Office Action Summary

10/735,030

SAADAT ET AL.

DETAILED ACTION

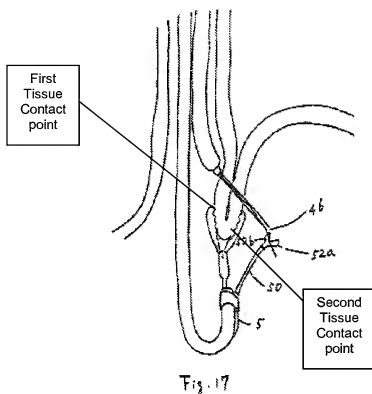
Jaffe discloses an overtube, guide tube (14), designed to facilitate insertion of an endoscope through a tortuous pathway ([0002]). The guide tube is slideably disposed over the catheter and comprises a flexible and rigid state (Figure 1; [0028]; [0037]; [0038]). As shown in Figure 3, tensioning elements (30) transition the overtube between the flexible and rigid states ([0041]). Therefore, tensioning elements (30) clearly overlap the instantly claimed mechanism. It is the examiner's position that the tensioning elements are configured to be manipulated from outside a patient's body. Since the overtube of Jaffe advantageously facilitates insertion of an endoscope through an internal passageway, it would have been obvious to one of ordinary skill at the time of the invention for Suzuki to utilize the overtube of Jaffe.

Additionally, Jaffe teaches the distal end of the guide tube can be controlled through a steering capability to provide an optimal pathway through the patient ([0044]). Tensioning elements (30) are also disclosed as steering the distal end of the overtube by causing it to "flex into different position" ([0044]) and therefore overlap the instantly claimed steering wires. Since Jaffe teaches multiple tensioning elements (30A, 30B, 30C, and 30D), it is the examiner's position that, for instance, tensioning elements 30A

and 30B overlap the instantly claimed steering wires and tensioning elements 30C and 30D overlap the instantly claimed mechanism to transition the overtube.
